Rev. 1: June 2025

FSN Ref : PM6/SS14/FSN

Urgent field safety notice Easymoov6 Enteral feeding pump

Urgent Field Safety Notice (FSN) Easymoov6 Enteral feeding pump Risk addressed by FSN

Appendix 1 : Reminder on tubing installation on Eaymoov6 enteral feeding pumps

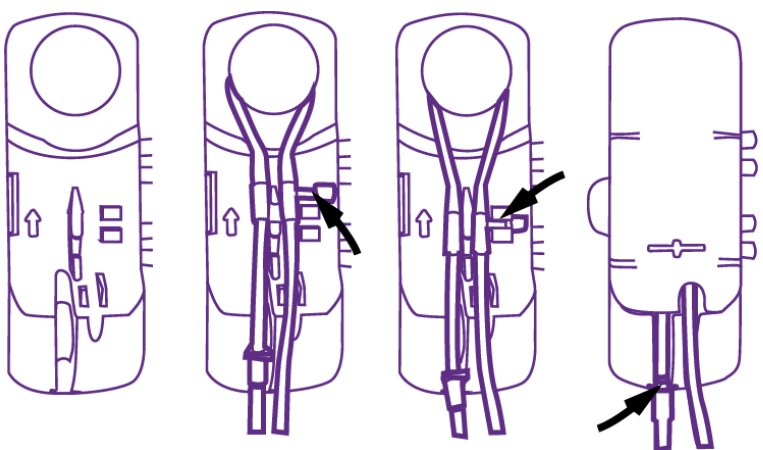
(1) Open Easymoov6 pump cover.	
(2) Place the silicone loop around the rotor and make sure the cassette is in the right direction.	
(3) Push the cassette in the middle of the pins with your thumb and make sure the cassette is well positioned between the two black pins. Guide both tubes down, in line with their respective slots.	
(4) Close the pump cover, then place the adapter into the designated slot.	
Remove the protective cap from the tubing.	
Launch automatic priming (see section 3.5).	<div>(1)</div> <div>(2)</div> <div>(3)</div> <div>(4)</div>
Connect the tubing to the patient enteral feeding tube and program the pump.

- **not to connect the tubing to the probe** before priming,
- **to check the correct position of the silicone tube** around the rotor:
